**Dear Editor,**

**Dear Referee 1,**

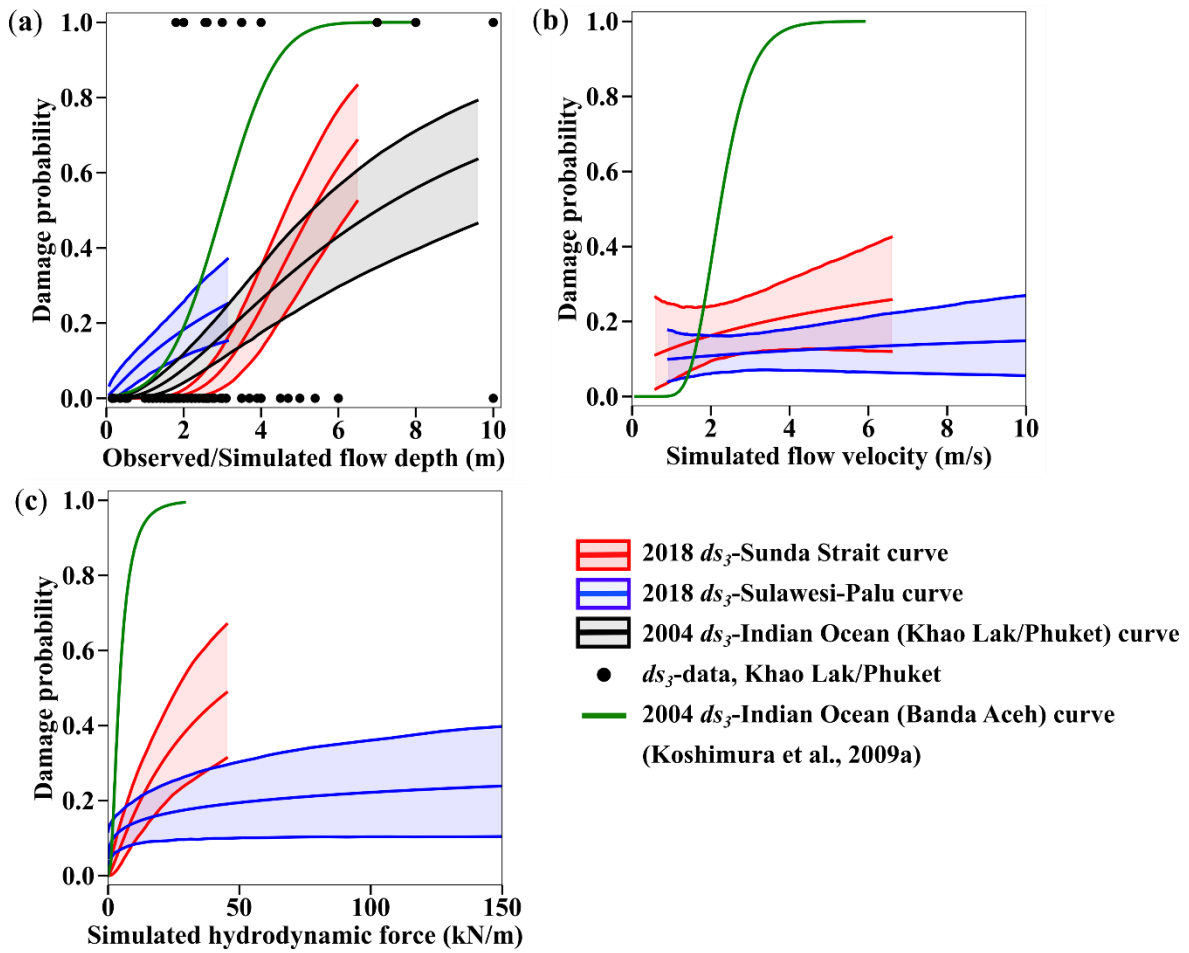
curves should be a part of the discussion (beyond the statistical confidence level etc). Can one use these functions reliably? Figure 16: From my perspectives, the comparison of the curves based on flow velocity and hydrodynamic force is not robust. I would suggest focusing on the flow depth based models which show some realistic fragility features.	the hydrodynamic force are not good predictors of damage. For this reason, we are not discussing the building damage probability based on these tsunami intensity measures for the 2018 Sunda Strait and Palu tsunami.	
---	--	--

Reviewer comments	Our answers	Corrected manuscript
<p>The authors present the fragility curves for the three events in the four locations (Fig. 16a). The curves demonstrate that for low flow depth values (less than 2 m flow depth) building fragility was largest in Palu 2018 followed by 2004 Banda Aceh, followed by 2004 Khao Lak, followed by Sunda Strait 2018. Above 2 m flow depth, the curves for 2004 Banda Aceh demonstrate the largest building fragility. The authors conclude that ground shaking and liquefaction contributed to the fragility curves for Palu 2018 and Banda Aceh 2004. Although it is possible that both ground shaking and liquefaction may contribute to the fragility curves, the authors do not demonstrate this. Hence their claim is pure speculation. To demonstrate that ground shaking played a significant role, the authors should present a measure of ground shaking that allows inferring the damage of buildings that have not been hit by the tsunami. Maybe they could use seismic intensities or peak ground acceleration to infer the damage of buildings that have not been hit by the tsunami. Alternatively, they could comment on which extent buildings were damaged outside the tsunami inundation area to foster their hypothesis.</p>	<p>We thank the reviewer for this comment. In Banda Aceh, the ground acceleration of the 2004 Indian Ocean earthquake was not recorded in the damage zone. The earthquake intensity is estimated to VII to VIII on the Modified Mercalli Scale. Ghobarah et al. (2005) also mentioned that buildings in Banda Aceh was strongly affected by the ground shaking (which lasted ~10 min) and tsunami damage was distinguished from seismic damage (e.g., substantial damage to infrastructure with 3-5 stories compared to low rise structures). For the 2018 Sulawesi-Palu tsunami, the main cause of structural damage is still investigated. The earthquake intensity is estimated to VII to VIII on the Modified Mercalli Scale (Supendi et al., 2019) but Kijewski-Correa and Robertson (2018) mentioned that the ground motion only slightly damaged the buildings in Palu-City.</p>	<p><b>Please, see the revised Section 6.2.</b></p>

Page 27, figure 16: I suggest adding the reference to the legend of the figure.	Corrected	<b>Please, see the revised Fig. 16 below.</b>
Page 28, table 13: It is not proven that a non-seismic source triggered the Palu tsunami. You need to explain what the symbols + and – mean in the lines liquefaction and ground shaking. I suggest changing the line 'Construction material' to 'Construction type'.	We agreed with the reviewer. Corrected.	<b>Please, see the revised Table 13.</b>
Page 28, line 514 f.: Why do you think the Sunda Strait event buildings reveal a better performance than in Khao Lak? How many buildings were affected in Sunda Strait with flow depth values larger than 5m? How much area was inundated with flow depth values larger than 5 m?	We made a mistake and corrected it. Thank you for pointing this out. 9 buildings collapsed with flow depth values larger than 5 m against 7 structures in Khao Lak/Phuket.	<b>Line 571:</b> As few data points for completely damaged buildings are available <b>beyond this value, the Sunda Strait and the Indian Ocean (Thailand) curves</b> reliability is insufficient. <b>Even though the long wave periods of the IOT (Thailand) seem to increase the likelihood of building damage, the sample size of collapsed buildings beyond 5-m flow depth is too short to confirm this assumption.</b>

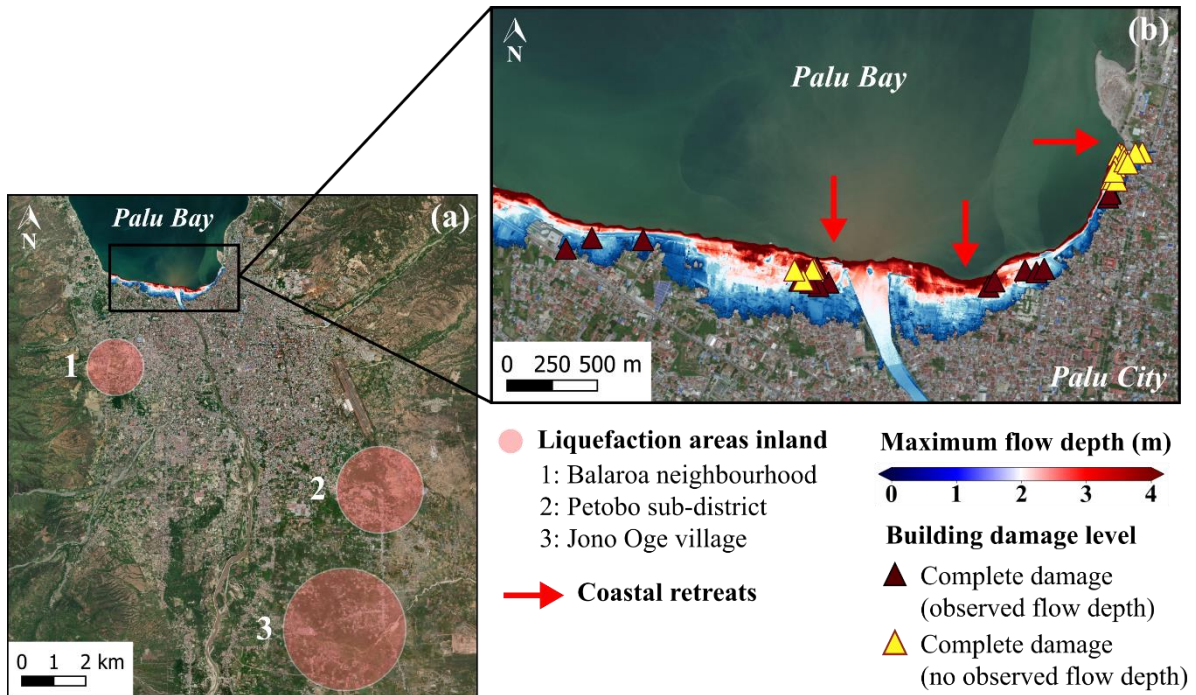
<p>The authors write in the conclusions, page 30, line 573 f. : ‘: : , it is clearly demonstrated that liquefaction events can increase building susceptibility.’ and page 30, line 574 f. : ‘: : , the building were previously affected by severe liquefaction episodes.’ This sentence is not a conclusion from their work. Most importantly is to mention that the largest liquefaction areas were located outside the</p>	<p>We thank and agreed with the reviewer. In this study, the term liquefaction refers to the ground failures in the waterfront of Palu-City. Even though the largest liquefaction areas were recorded outside the tsunami inundation zone (Watkinson and Hall, 2019), Sassa and Takagawa (2019) and Kijewski-Correa and Robertson (2018) observed land retreats along coastal</p>	<p><b>Please, see the revised Section 6.2 and Fig. 17 below.</b></p>

<p>tsunami inundation areas. The authors should consult Watkinson and Hall (2019) and Syifa et al. (2019). Even though Sassa and Takagawa (2019) conclude that they found evidence for extensive liquefaction in coastal areas, the authors should quantify how many of the database's observed buildings were affected by liquefaction. The authors could overlap the liquefaction areas with figure 8 to see how many of the buildings were affected. The current state of the manuscript does not allow to conclude that buildings were weakened by liquefaction. Moreover, Mas et al. (2020) write that tsunami hydrodynamic and debris impact forces may have been the principal causes of failure and collapse in Palu Bay's waterfront area.</p>	<p>areas of Palu-City, which is highly vulnerable to liquefaction disaster (Darma and Sulistyantara, 2020; Kijewski-Correa and Robertson, 2018). In Palu post-tsunami database (DB_Palu2018), many masonry-type buildings do not have a flow depth value because they have been washed away. In Figure 17, many masonry-type buildings completely damaged are very close to these coastal retreats. Moreover, the likelihood of complete damage is very high for low inundation depth levels. This feature is usually observed for building suffering prior damage (e.g., ground shaking and/or liquefactions episodes), as mentioned by Charvet et al. (2014), for the 2011 Great East Japan event. Here, the likelihood of complete damage is higher in Palu than in Banda Aceh under 2-m flow depth. So, even if ground shaking is not the main cause of destruction, it may have triggered liquefactions in the waterfront of Palu-City and enhanced the building susceptibility to tsunami damage. This assumption cannot be verified through satellite images, it needs direct and close observations, which might have been erased by the tsunami. On the other hand, Mas et al. (2020) suggested that the tsunami hydrodynamic or debris impact might be the main cause of structural destruction in the waterfront area of Palu-Bay. As the flow velocity and the hydrodynamic force are not good descriptors of tsunami damage, we cannot support this assumption.</p>
